UNITED STATES PATENT AND TRADEMARK OFFICE

| APPLICATION NO. | FILING DATE | FIRST NAMED INVENTOR | ATTORNEY DOCKET NO. | CONFIRMATION NO. |
|---|-------------|----------------------|---------------------|------------------|
| 10/622,784 | 07/21/2003 | Kenji Utsunomiya | 402716/SOGA | 4261 |

Office Action Summary

The following title is suggested : Active Horizontal Elevator Vibration Suppression Device

Fig. 1

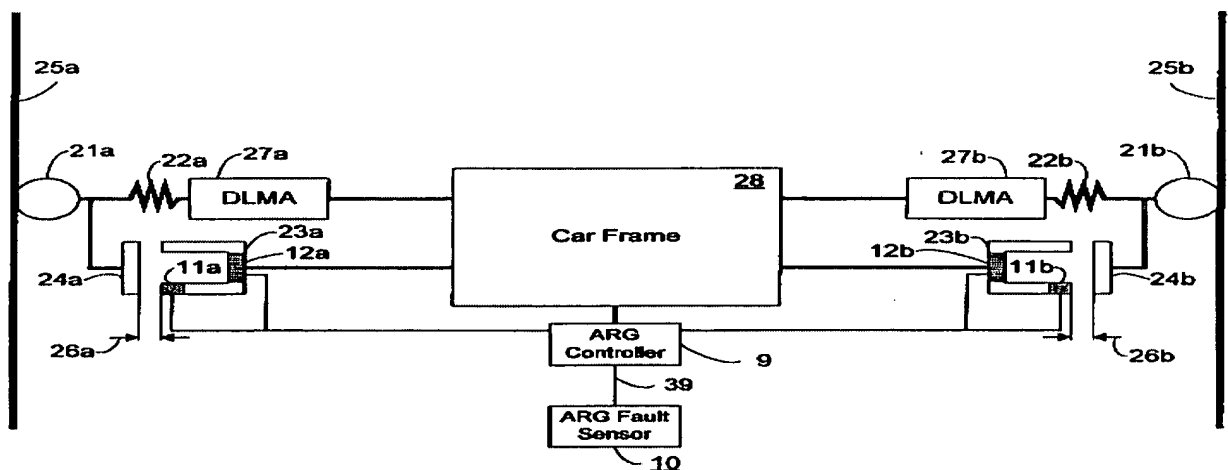
Jamieson et al teaches in figures 1-4, an elevator active guide fault sensor system.

A vibration magnet 23a,23b contains sensors 11a,11b which control actuators 27a,27b to center the car 28 in the shaftway horizontally. A detection sensor 10 compares the sensor values. If the values fall above a limit 51 the actuator is shut-off 52.
